**Subject: Zoning By-law Amendment - 2040 Arrowsmith Drive**

**File Number: ACS2025-PDB-PS-0006**

**Report to Planning and Housing Committee on 19 February 2025**

**Submitted on February 7, 2025 by Derrick Moodie, Director, Planning Services,  
Planning, Development and Building Services**

Figure 4: Proposed site plan showing location of building, parking, and landscaping. Source: Site Plan, Drawing A000, prepared by Vandenberg and Wildeboer Architects, dated 2022, revision 6 dated January 17, 2025.

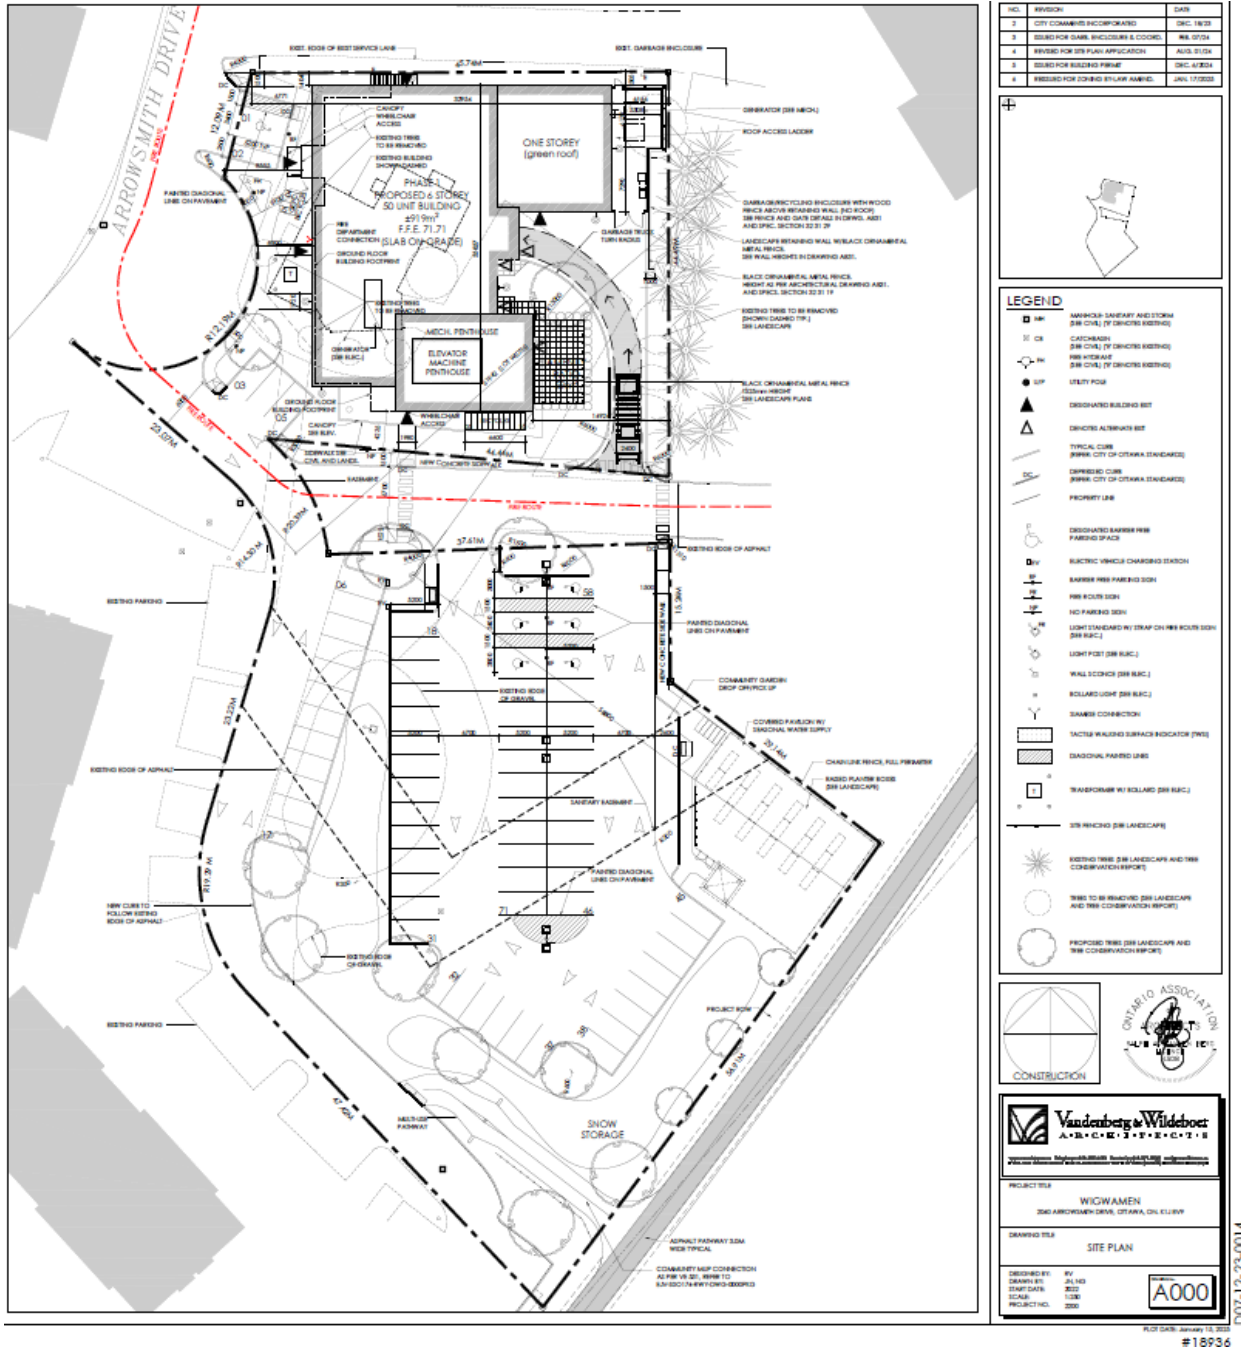
**Maintenance of Right-of-way:** Community member had questions regarding the maintenance of the existing right-of-way adjacent to the site (known as Sutton Place Lane), including snow removal. Historically, snow has been stored on 2040 Arrowsmith where the new parking area is proposed. Concerns were expressed over the potential rise in maintenance costs for current residents.

The existing right-of-way that provides access to neighbouring condominiums (CCC 11 and CCC 25) will remain. Adequate snow storage has been shown on the proposed site plan around the parking area. Any required agreements for maintenance or cost sharing will be dealt with at the site plan control stage of the planning application process.

Figure 7: Aerial View Looking North Source: 2040 Arrowsmith Drive, Ottawa Design Brief prepared by SHS Consulting dated September 2023.

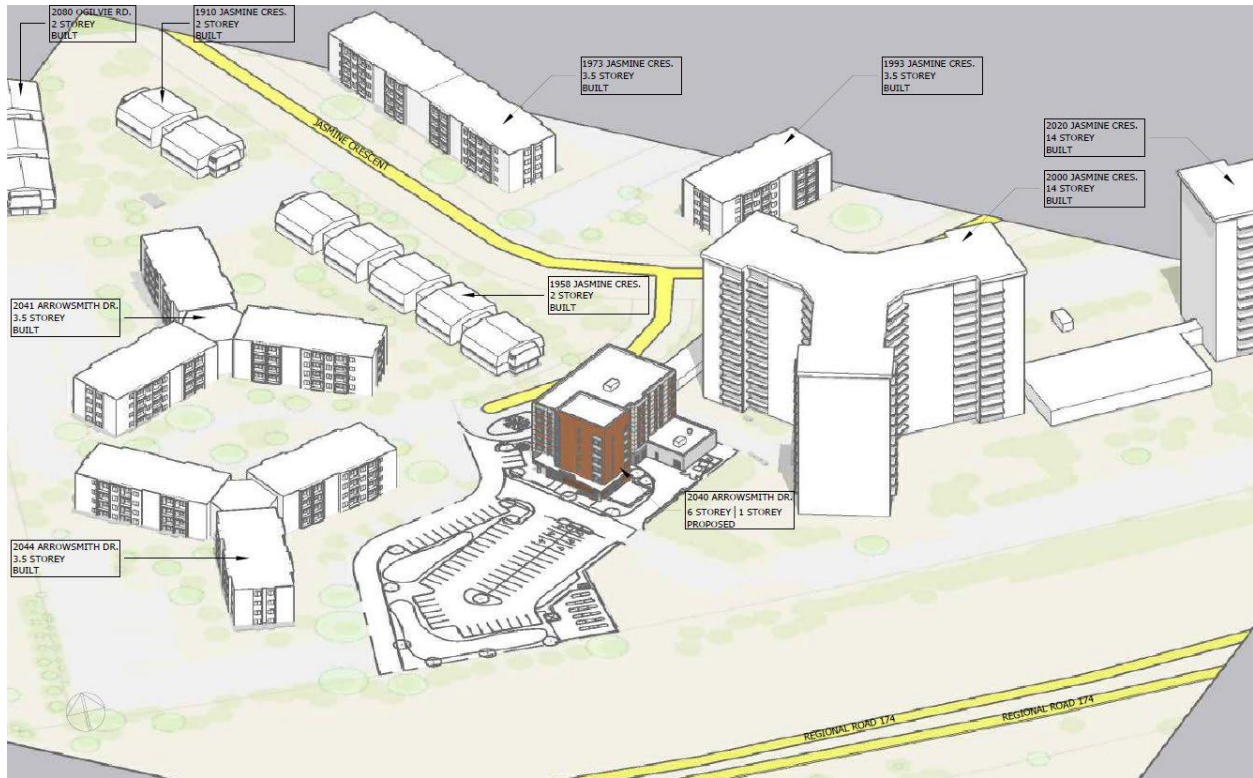
**Design:** A couple community members raised concerns over the building's design and location. One issue regarded the building's materials and whether the structure would be constructed with wood. Concern was expressed over the potential fire hazard if the new building was of wood construction.

Questions were also raised over the location of the building in proximity to the adjacent building at 2000 Jasmine Crescent. Residents have expressed concerns over the potential loss of sunlight and privacy from the proposed building.

One community member also expressed similar concerns over the building height of the proposed development for similar concerns regarding the possible the loss of privacy, views, and natural light for their unit.

The apartment building will be placed at the north end of the site, framing the public streetscape along Arrowsmith Drive. The building location was selected for design reasons (pedestrian access, transition in built form and scale), as well as practical considerations (the location of underground utilities beneath the southern portion of the site). The site is heavily constrained with an irregular lot fabric and the existing right-of-way (Sutton Place).

The height and footprint of the proposed building is complementary to the surrounding built form. The 6-storey apartment creates a transition between the interface of the 14-storey residential condominium apartment building to the north and east, and the 3.5 storey low rise apartments to the west, see Figure 7 below.

There is adequate separation between the buildings at 2000 Jasmine Crescent and 2040 Arrowsmith Drive given that 2000 Jasmine Crescent is set farther back from Arrowsmith Drive than the new building and there are limited windows on the north face of the new building. See Figure 30 of the 2040 Arrowsmith Drive, Ottawa Design Brief prepared by SHS Consulting dated September 2023, page 32.
